TO: All Interested Bidders
SUBJECT: Invitation for Bid# 16-2231-DS
Force Main Replacement Project at Windmill Village

ADDENDUM #1

Addendum # 1 to IFB# 16-2231-DS

Test Locations/Soil Boring Logs
 Windmill Village Force Main
 Bayshore Gardens Pkwy & Saunders Rd.
 Bradenton, Manatee County, Florida

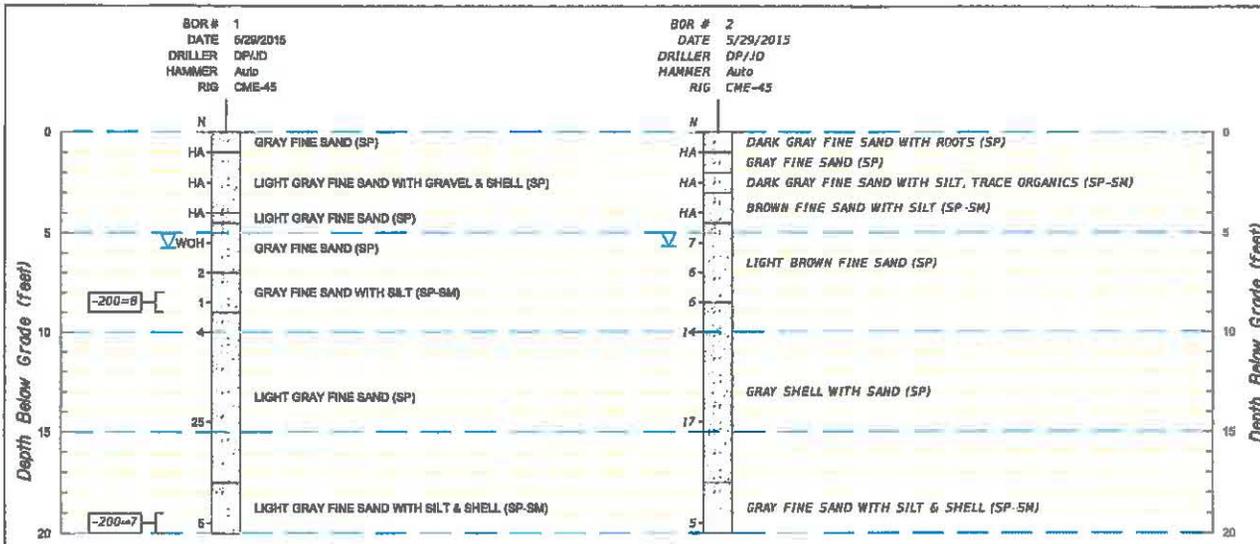
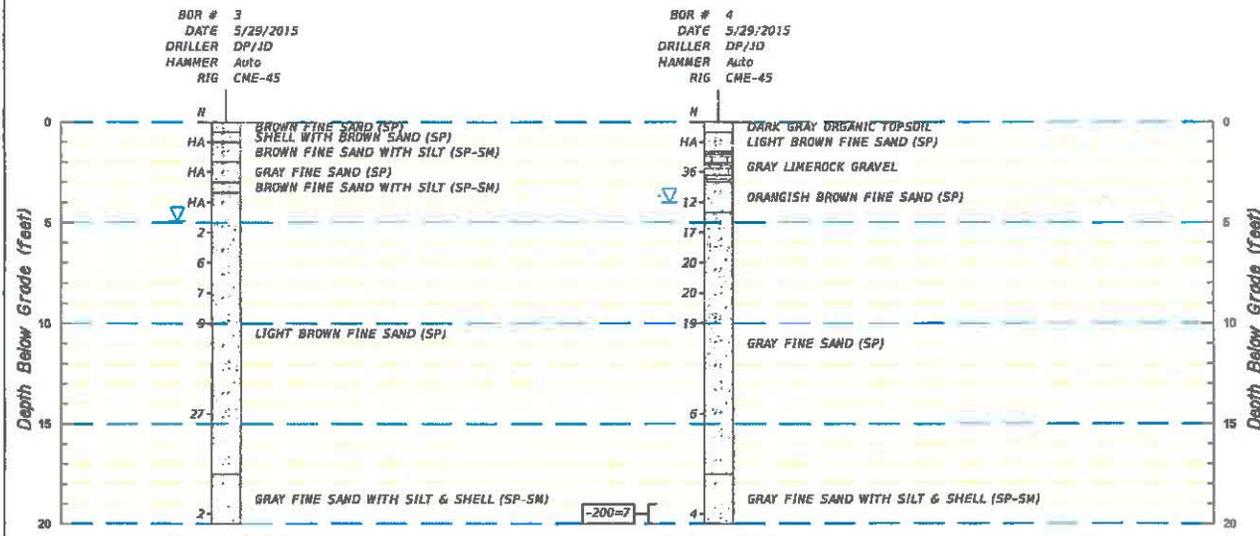
Question # 3: Please provide soil borings along the route of the pipe line.

Response # 3: The geotechnical report for the project is attached to this addendum.
